**APPLICATION FOR COMMERCIAL BUILDING PERMIT**

NATURE OF WORK IN DETAIL: ~~FIRE SUPPRESSION~~  
12 NEW FIRE HYDRANTS & LOOPS  
Ref 9905675C correction notice

RE: Inspection of Soil Conditions:  
Hydrant No. 2 Branch Tee and Shoe;  
Florin Perkins Landfill Permanent Fire System  
4201 Florin Perkins Road, Sacramento, CA

**Re: Florin Perkins Landfill**

PIPE LOCATING WIRE FOR  
NON-CONDUCTIVE WATER MAINS

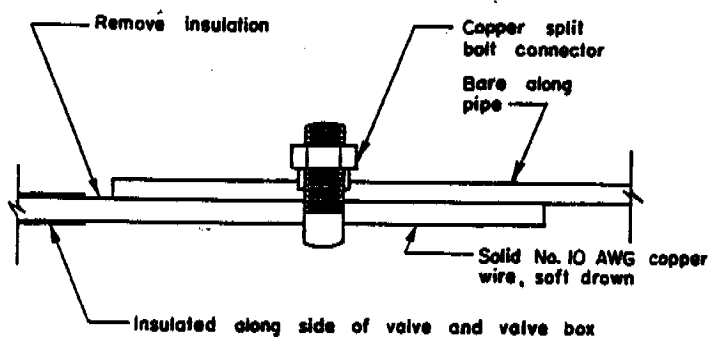
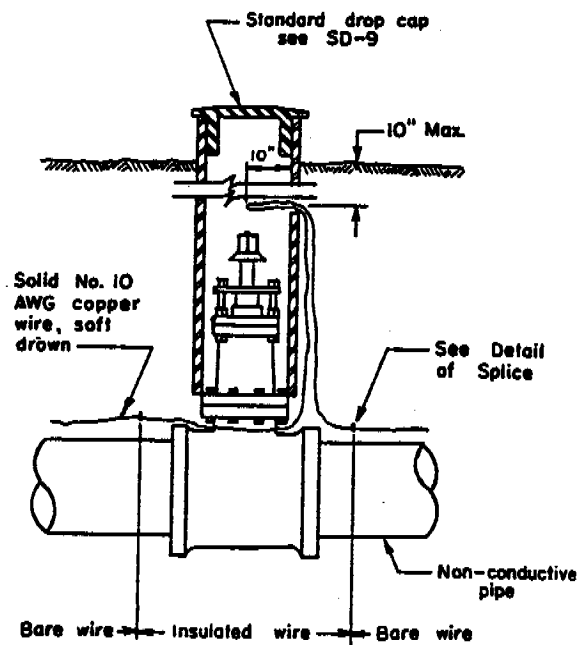
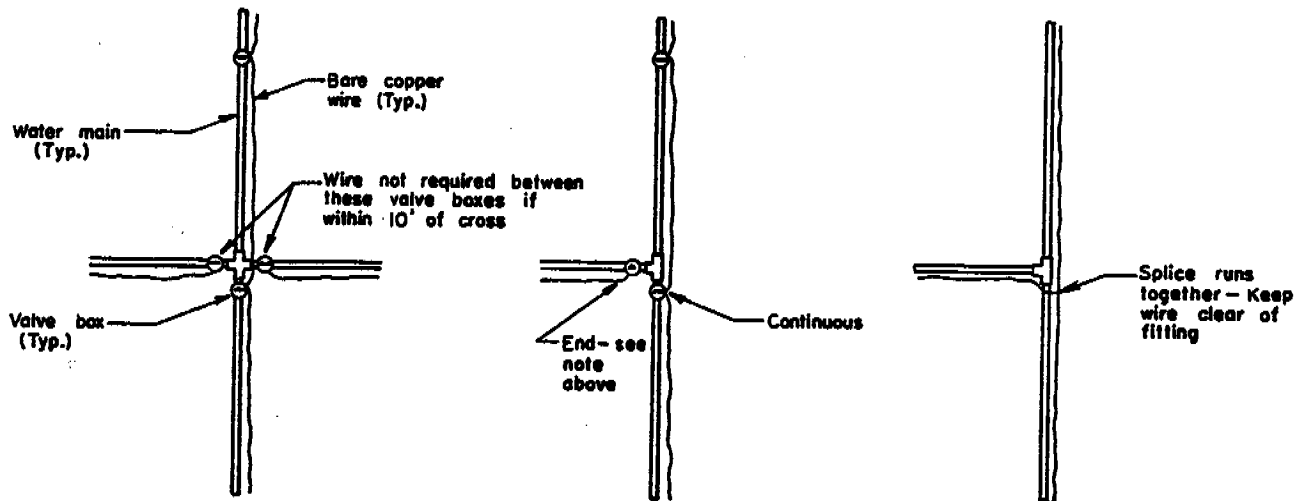
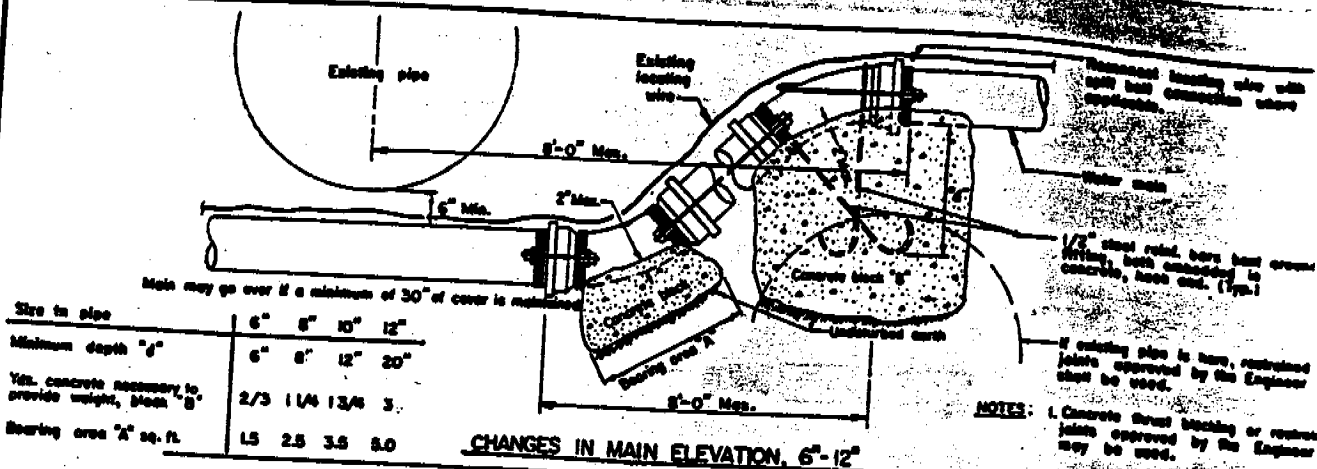
- d. spliced with a split bolt connection per City of Sacramento standard drawing SD- 2.
  - e. installed at the valve box risers and at the fire hydrants per City of Sacramento standard drawing SD-1 and SD-2.

CITY OF SACRAMENTO WATER DIVISION	CHANGES IN MAIN ELEVATION & THRUST BLOCKING FOR WATER MAINS	APPROVED BY: <i>[Signature]</i>	SCALE: NONE
		DATE: JAN. 1989	DWG. NO. SD-7

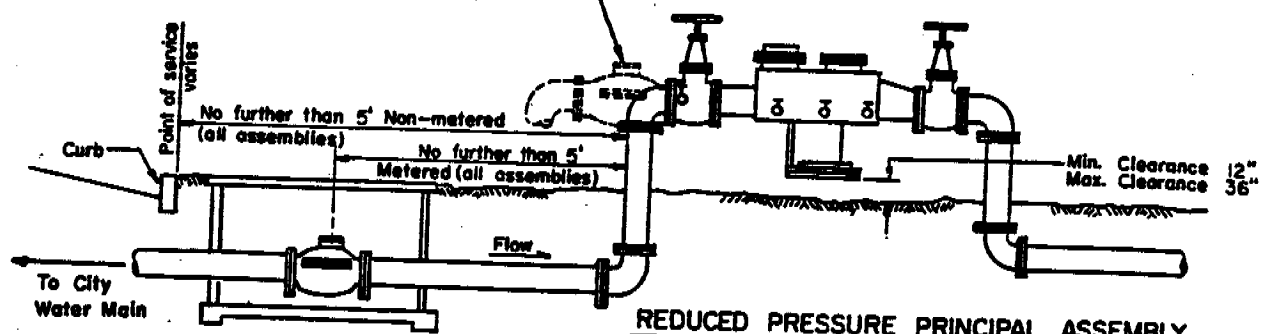
1. All portions of the piping system shall be inspected before covering.
2. All thrust blocks shall be installed and sized per City of Sacramento Standard Drawing SD- 7.

3. Thrust blocks installed in loose fill areas shall be designed to resist piping movement by shear weight of concrete alone.
4. Locating wire shall be:

APPROVED BY: *[Signature]* DATE: JAN. 1989  
SCALE: NONE  
DWS. NO. SD-15

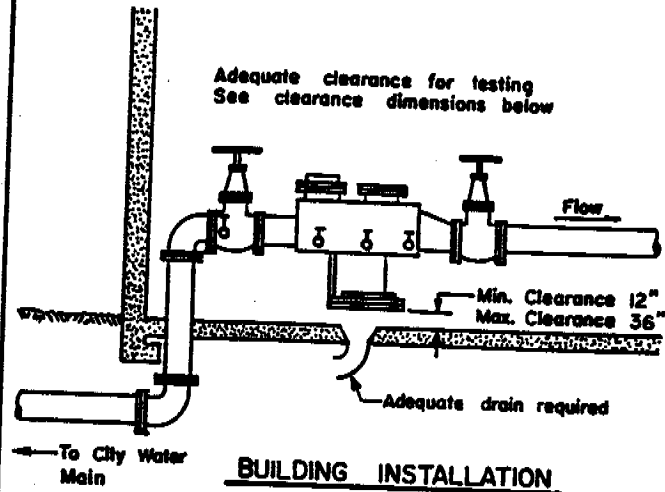
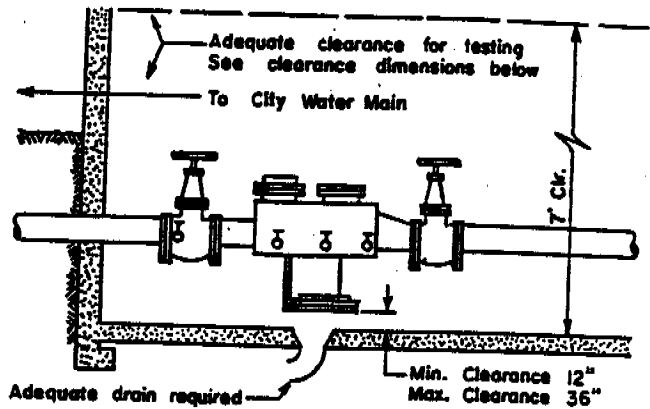
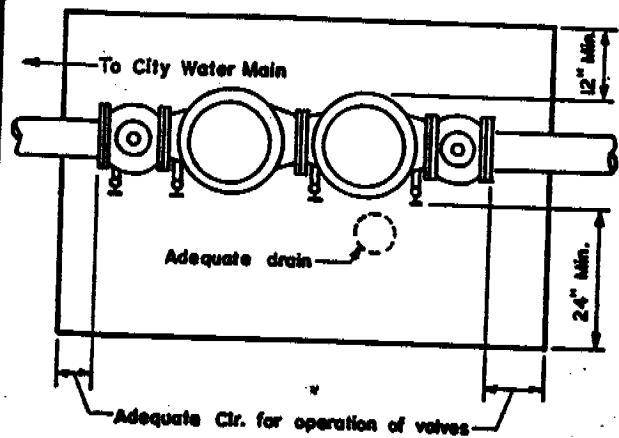
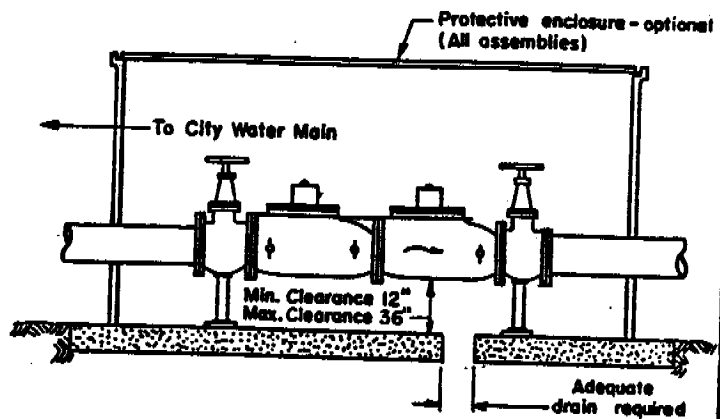
5. Backflow assemblies shall be installed per City of Sacramento standard drawing SD-15.
6. Pipe bedding and initial backfill shall be compacted sand. Secondary backfill shall be native soil free of concrete or other debris. Special care should be taken in those areas where the piping is installed in the landfill area.
